CANDLESTICK POINT–HUNTERS POINT SHIPYARD PHASE II DEVELOPMENT PLAN PROJECT

Comments & Responses

Volume VII: Comments & Responses (Section A through Letter 49)

San Francisco Redevelopment Agency File No. ER06.05.07
City and County of San Francisco Planning Department File No. 2007.0946E
State Clearinghouse No. 2007082168

FIGURE III.N-7

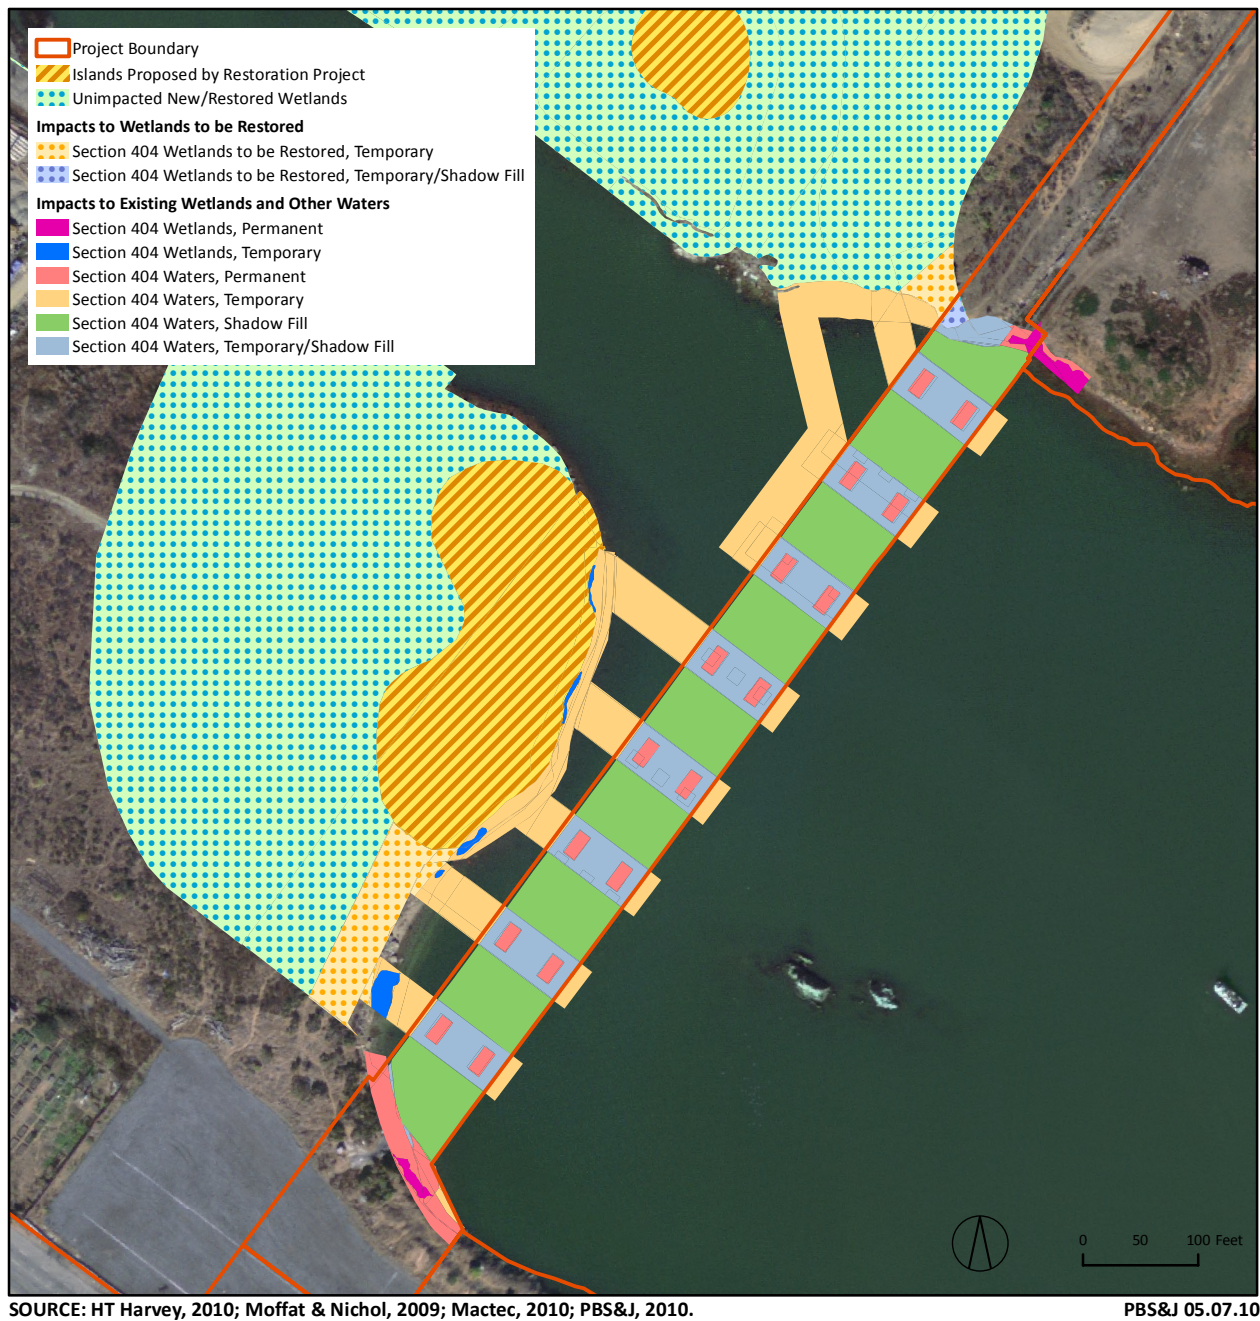
To more directly respond to public concerns, the following text has been added to the cumulative impacts discussion (before the first partial paragraph on page III.N-122 of the Draft EIR) to provide a more detailed discussion of impacts to future wetland and aquatic habitat in consideration of the Restoration Project:

In response to public concerns, impacts to future wetland and aquatic habitat in consideration of the Yosemite Slough Restoration Project have been quantified. If the Restoration Project is implemented before the Yosemite Slough bridge is constructed, then the bridge would impact not only existing wetlands, aquatic habitats, and mud flats, but also sensitive habitats that have been restored by the Yosemite Slough Restoration Project. Based on the final Phase I Restoration Plan

FIGURE III.K-5

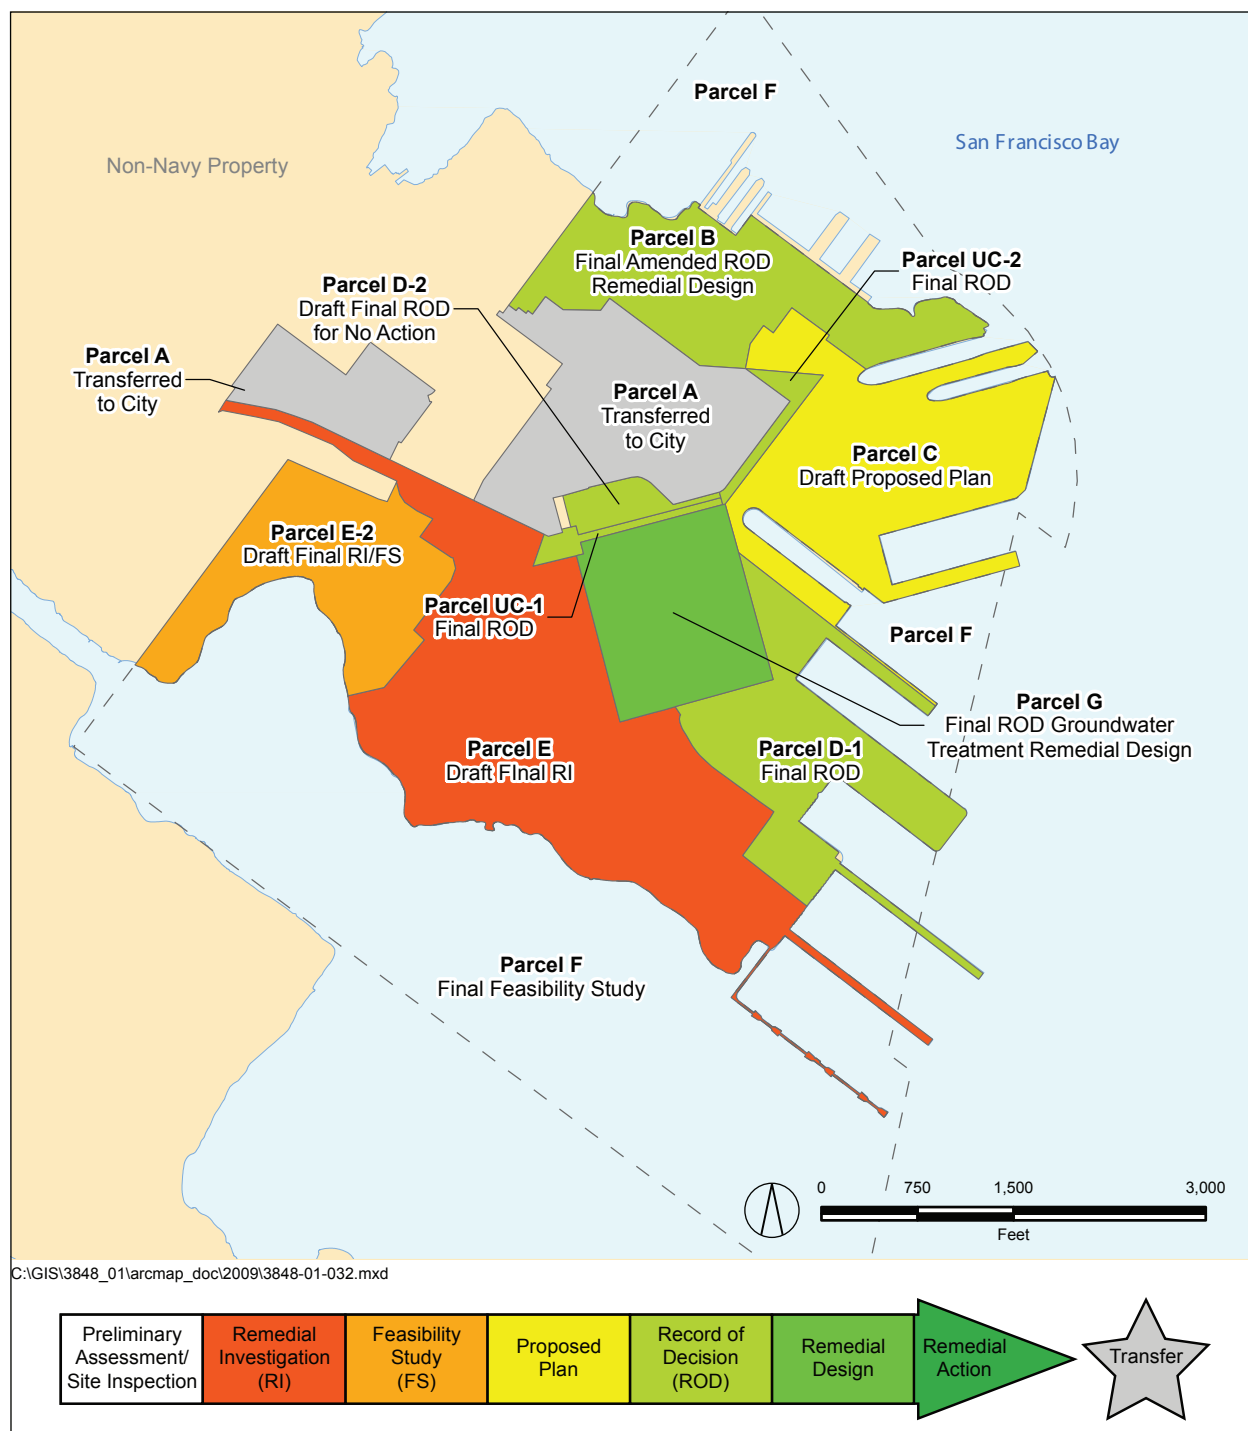
- Inquiring about the status of the cleanup on the various Shipyard parcels

FIGURE C&R-3a

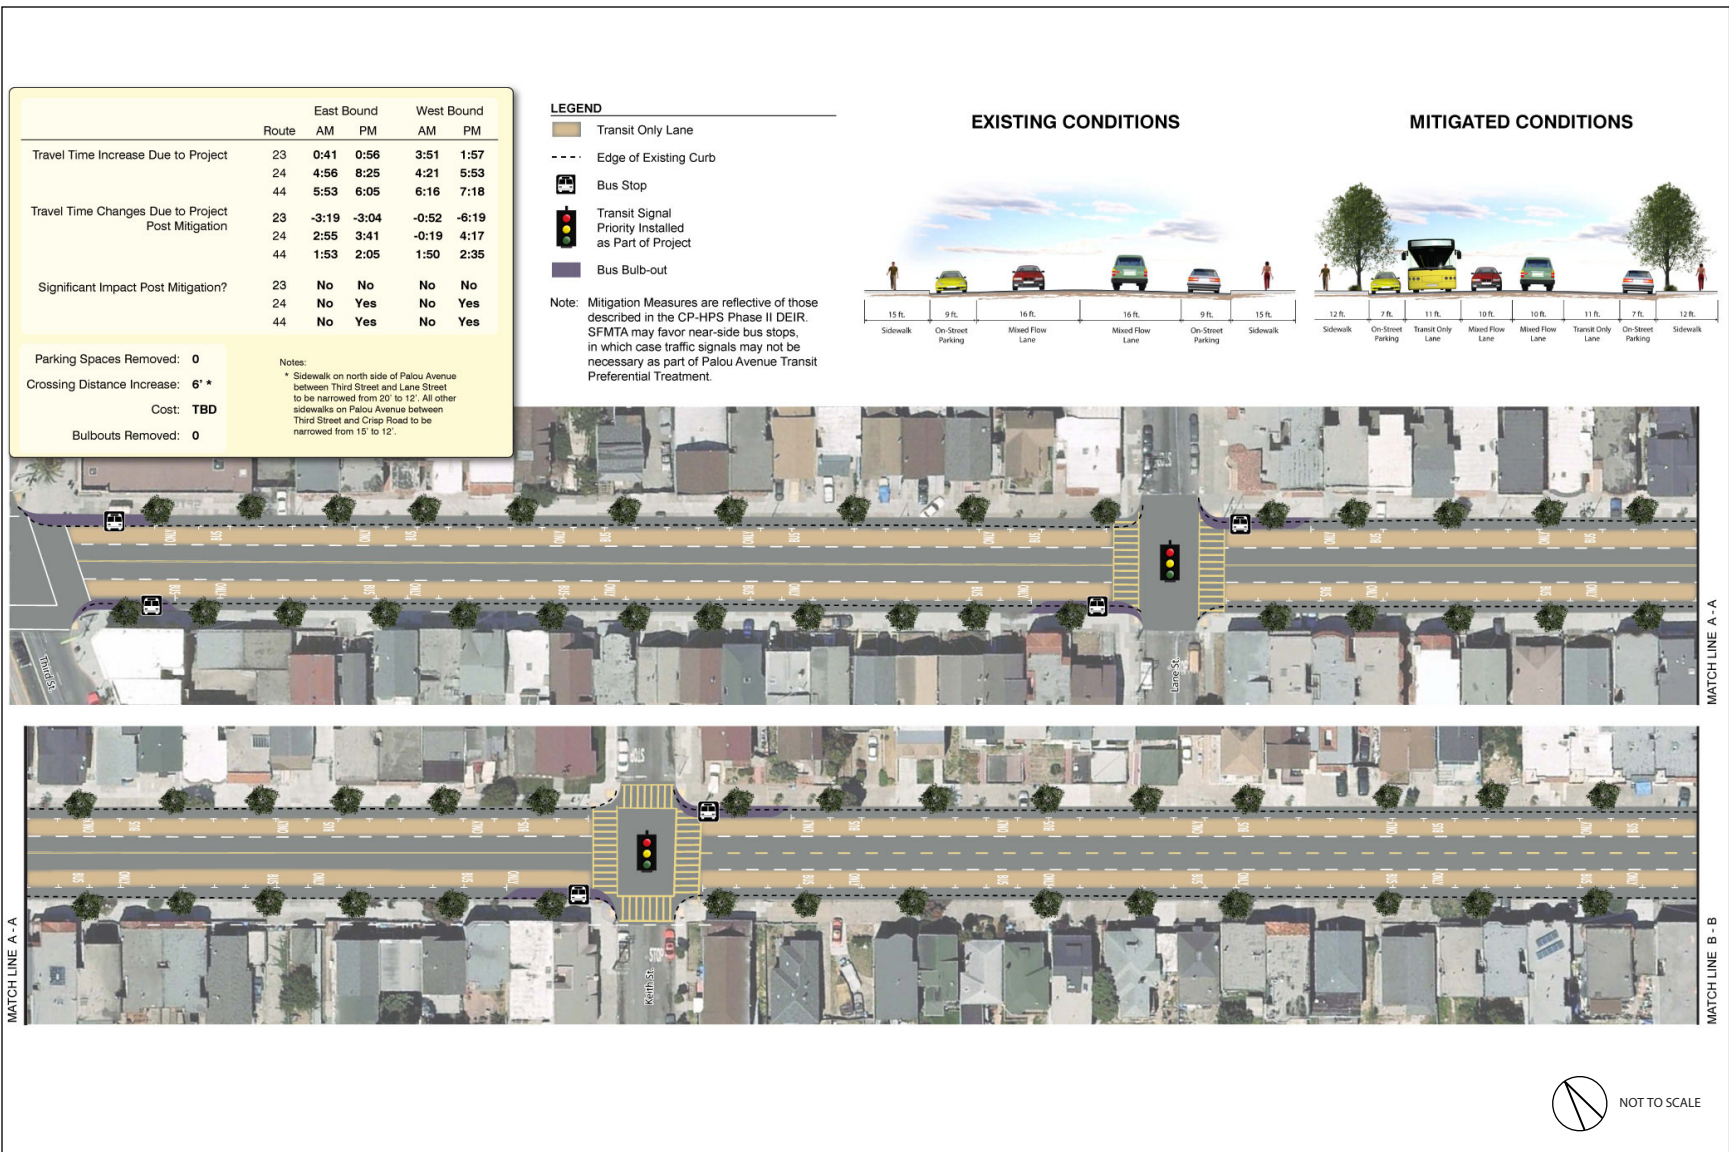
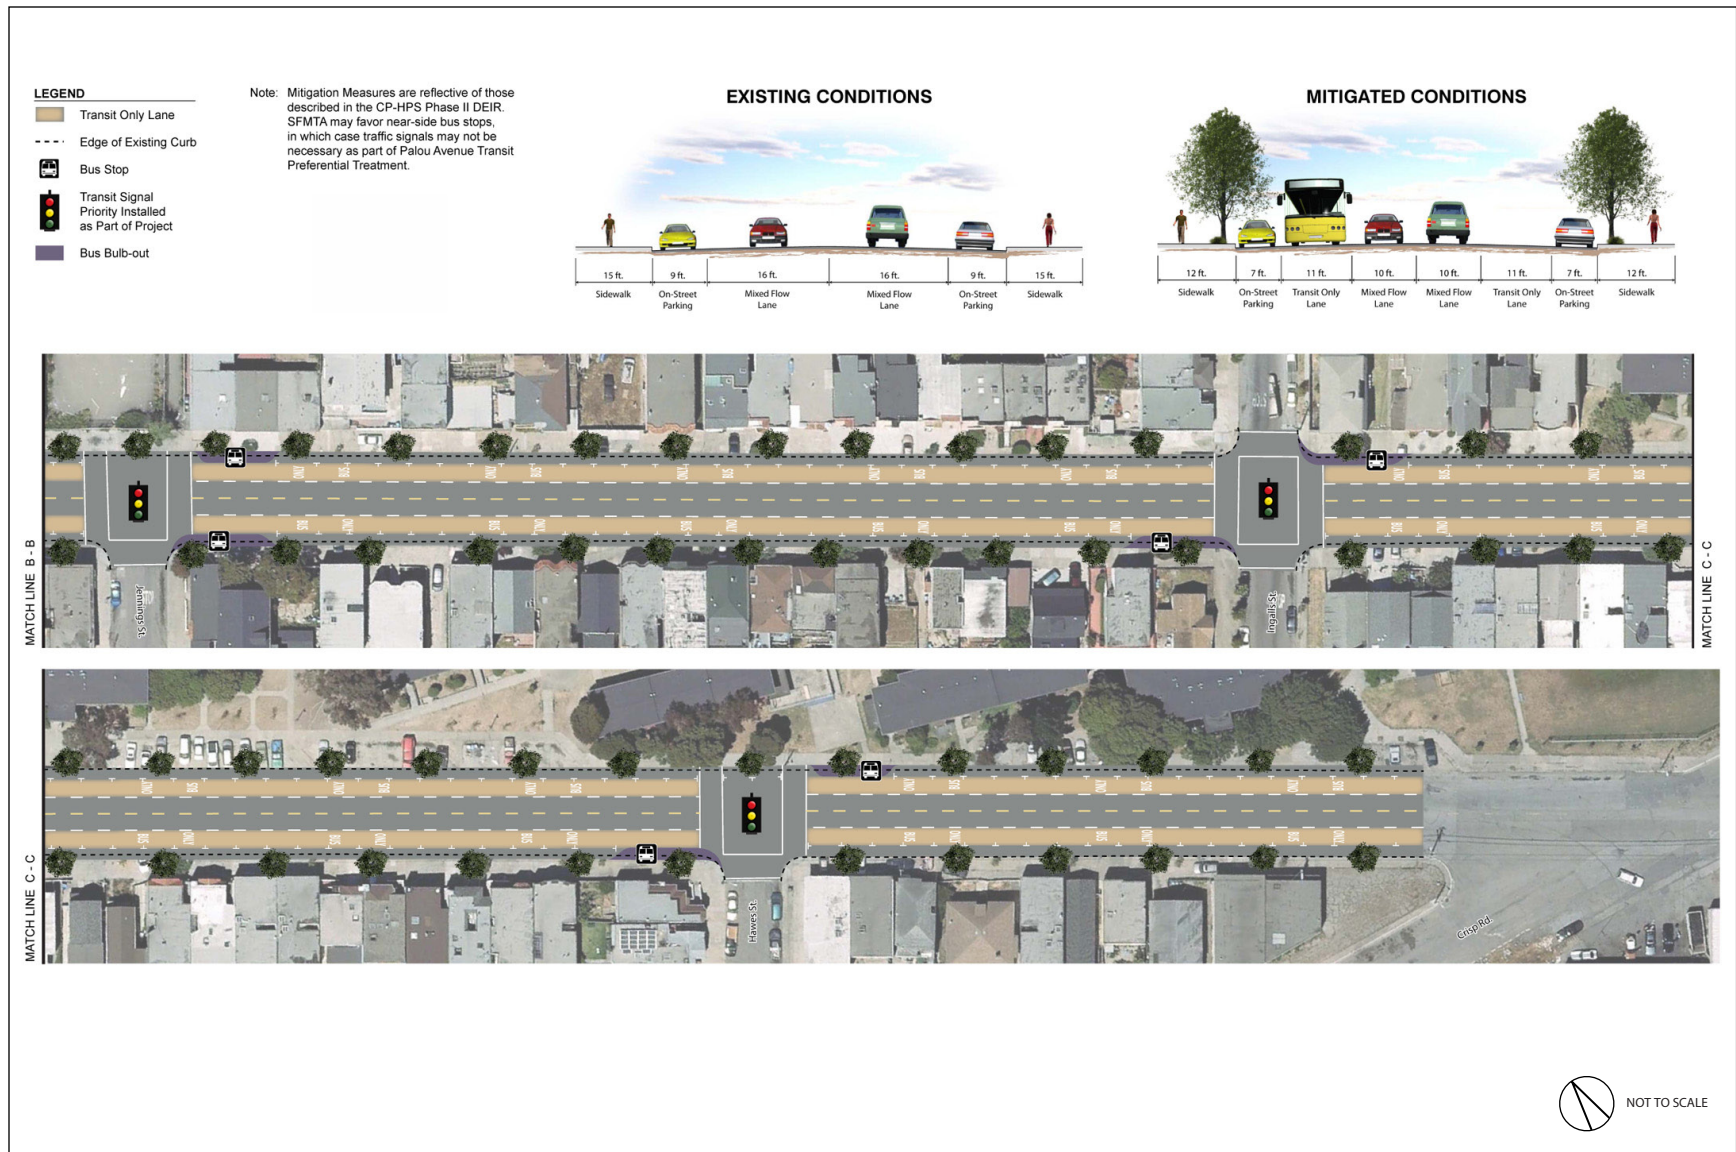
Mitigation measure MM TR-22.1 included a number of optional improvements to the Palou Avenue corridor aimed at reducing Project-generated transit delays. Subsequent to publication of the Draft EIR, the Project Applicant and SFMTA conducted a feasibility study. The fifth bulleted item in MM TR-22.1 was determined to be the most desirable of the optional measures because it would provide continuous transit-only lanes along the entire length of Palou Avenue between Crisp Avenue and Third Street, the transit-only lanes could be in operation at all times, and this option would retain on-street parking along the primarily residential corridor.

Specifically, as currently envisioned, mitigation measure MM TR-22.1 would add a transit-only travel lane in each direction on Palou Avenue between Crisp Avenue and Third Street. To accomplish this without removing existing on-street parking along Palou Avenue, existing sidewalks would be narrowed from 15 to 12 feet, allowing a 7-foot on-street parking lane, an 11-foot transit-only lane, and a 10-foot auto travel lane in each direction. The resulting 12-foot sidewalk widths would remain consistent with the City's Draft Better Streets Plan. Further, so-called "bus bulbs" could be provided at corners with bus stops, to provide additional passenger waiting areas and amenities, reduce pedestrian crossing distances, and eliminate the need for buses to pull over to the curb at stops. There would be no additional loss of on-

Mitigation measure MM TR-22.1 would benefit the 23-Monterey, the 24-Divisadero, and the 44-O'Shaughnessy. Figure C&R-3a (Mitigation Measure MM TR-22: Palou Avenue from Third Street to Crisp Road) and Figure C&R-3b (Mitigation Measure MM TR-22: Palou Avenue from Third Street to Crisp Road) illustrate the proposed mitigation measure, as well as the anticipated benefits to transit travel times on each of the impacted transit routes. The figures indicate the increases to transit travel times associated with project-generated contributions to traffic congestion for each affected route along the subject corridors (as presented in Table 76 in the *Transportation Study*). Because the mitigation measures do not fully mitigate the Project's increases to transit travel times in all cases, the figures also indicate how much the Project (with implementation of the mitigation measures) would increase transit travel times and whether the remaining increases would remain significant impacts or whether they would be reduced to less-than-significant levels. Finally, the figures also provide some description of other effects of the mitigation measures, including increases to pedestrian crossing distances, parking, and traffic congestion.

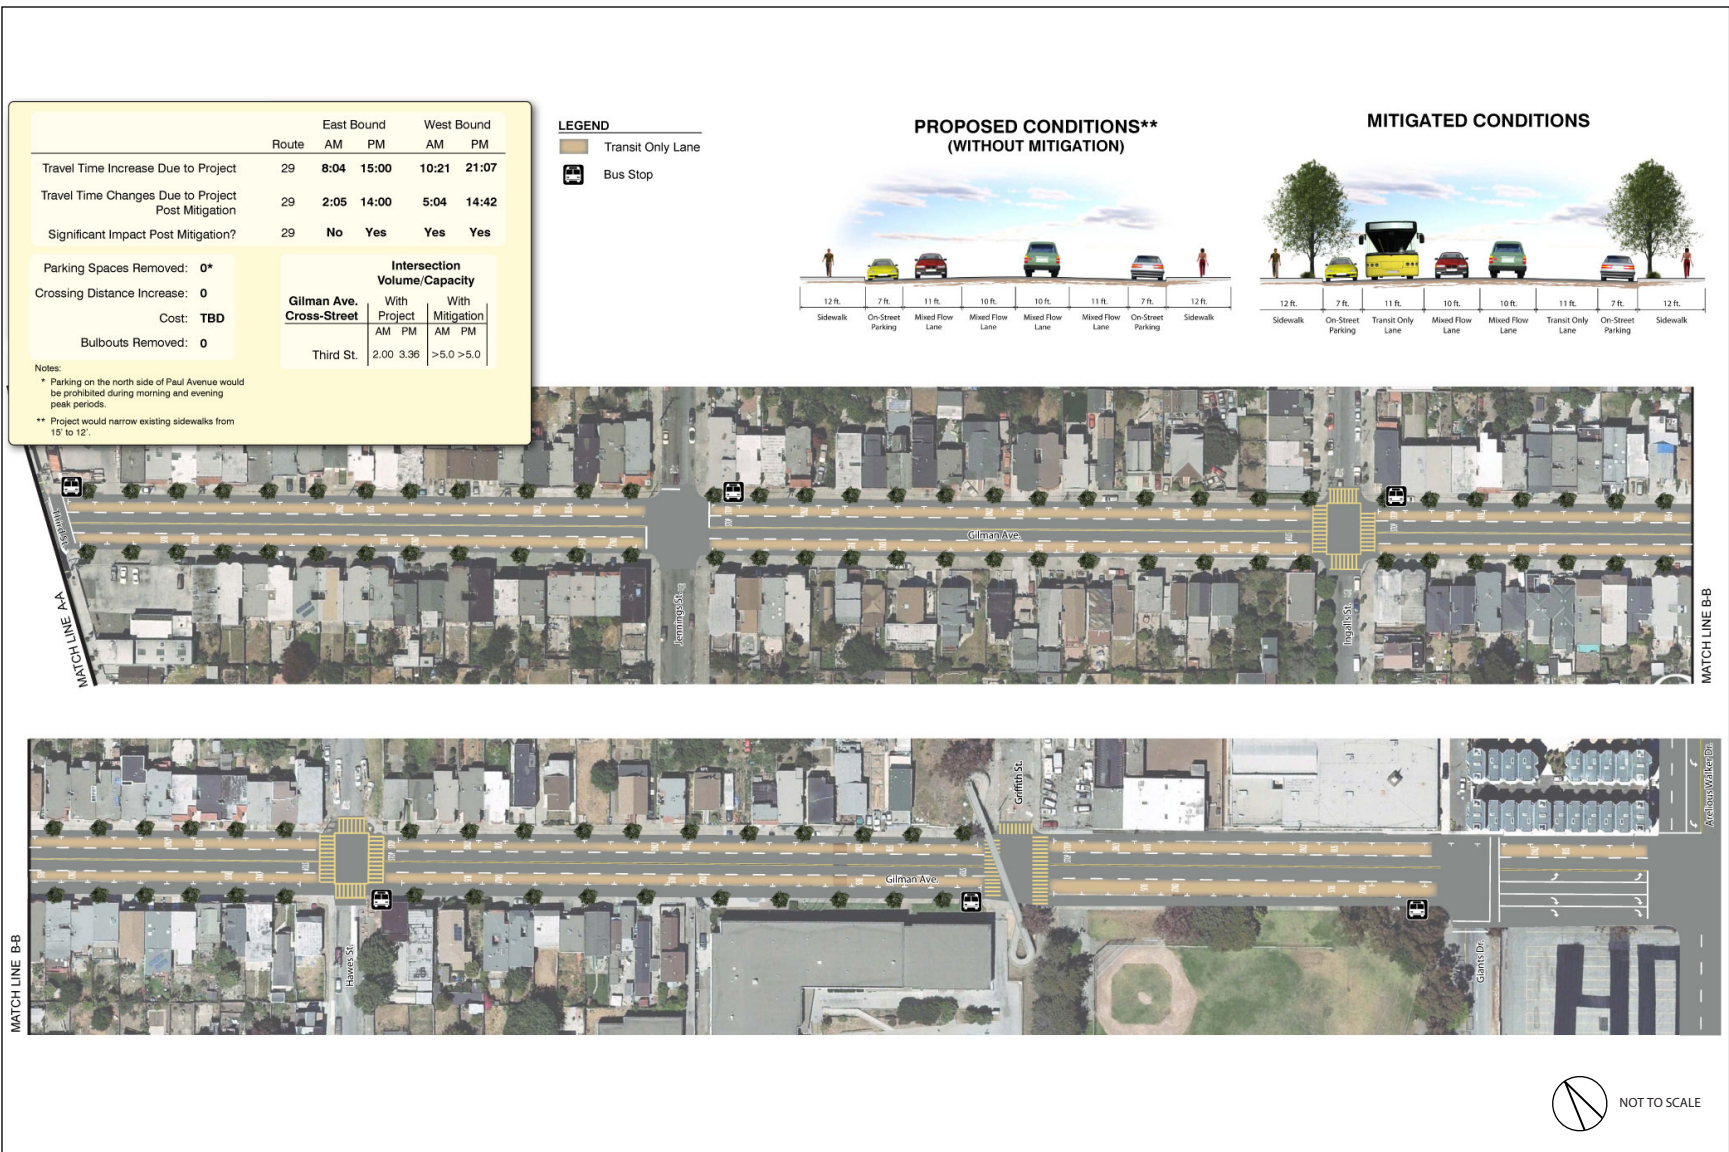
Mitigation measure MM TR-23.1 included a number of optional improvements to the Gilman Avenue corridor aimed at reducing Project-generated transit delays. Subsequent to publication of the Draft EIR, the Project Applicant and SFMTA conducted a feasibility study. The third bulleted item in MM TR-23.1 was determined to be more desirable than the first two bulleted optional measures because it would provide continuous transit-only lanes along the entire length of Gilman Avenue between Arelious Walker Drive and Third Street, the transit-only lanes could be in operation at all times, and this option would retain on-street parking along Gilman Avenue at all times.

Specifically, as currently envisioned, MM TR-23.1 would convert one of the two automobile travel lanes in each direction into a transit-only travel lane on Gilman Avenue between Arelious Walker Drive and Third Street. Additionally, westbound Paul Avenue, between Third Street and Bayshore Boulevard, provides one westbound travel lane and on-street parking. The on-street parking along this route is currently converted to a second westbound travel lane following San Francisco 49ers games at Candlestick Park. Mitigation measure MM TR-23.1 also calls for converting this on-street parking/travel lane to a transit-only lane during weekday morning and evening peak periods. This would temporarily reduce the on-street parking supply on the north side of Paul Avenue during peak periods only. As noted in the Draft EIR, implementation of this mitigation measure would exacerbate levels of service (LOS) F conditions for autos along the corridor; however, the effective prioritization of transit circulation over automobile circulation would be consistent with the City's "Transit First" policy. Based on the additional review of this mitigation measure, it appears technically feasible.

Mitigation measure MM TR-23.1 would benefit the 29-Sunset. Figure C&R-4a (Mitigation Measure MM TR-23: Gilman Avenue and Paul Avenue from Arelious Walker Drive to Bayshore Boulevard) and Figure C&R-4b (Mitigation Measure MM TR-23: Gilman Avenue and Paul Avenue from Arelious Walker Drive to Bayshore Boulevard) illustrate the proposed mitigation measure, as well as the anticipated benefits to transit travel times on the impacted transit routes. Although SFMTA has generally indicated support for this measure, as noted in the Draft EIR, implementation of this mitigation measure requires additional evaluation by the City and the impacts to transit remain significant and unavoidable.
